Reference: 016243.200

February 1, 2019

Subject: Comments on the Draft NPDES Permit for the Korbelt Sawmill, NPDES Permit No. CA0005932; WDR Order No. R1-2019-0005; WDID No. 1B80020OHUM, Place ID 235227

Figure 1. RSW-001 Receiving Water Hardness, February 2014 through December 2018

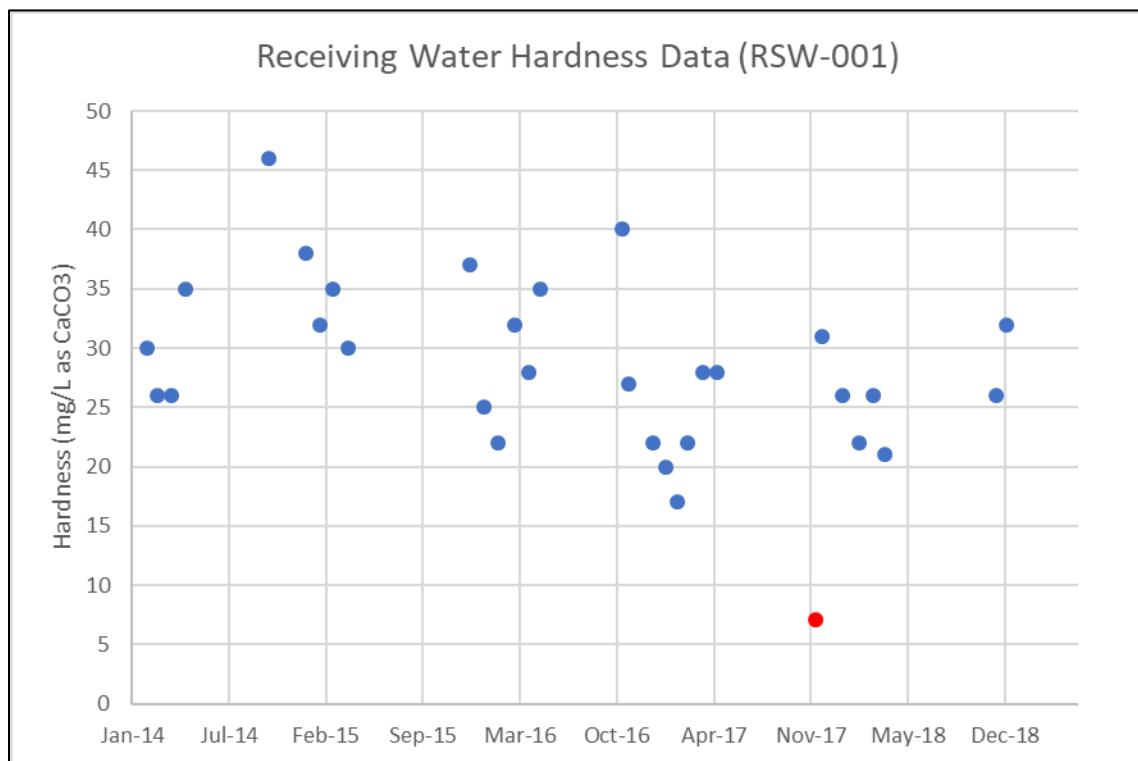
Based on the review of the hardness data collected over the last 5 years of the permit term, it appears the 7 mg/L as CaCO₃ hardness data value is an outlier data value. The 7 mg/L as CaCO₃ hardness data value is both an inconsistent and questionable data point that is unrepresentative of the general hardness trends in the North Fork Mad River, as exhibited by the statistical analyses and graph presented above. The next lowest receiving water hardness value recorded at RSW-001 is 17 mg/L as CaCO₃. If the 17 mg/L as CaCO₃ hardness value is used in place of the 7 mg/L as CaCO₃ value to determine the water quality objectives for the hardness-dependent metals, nickel and zinc, the data would exhibit no reasonable potential to cause or contribute to an exceedance of water quality objectives for either constituent.
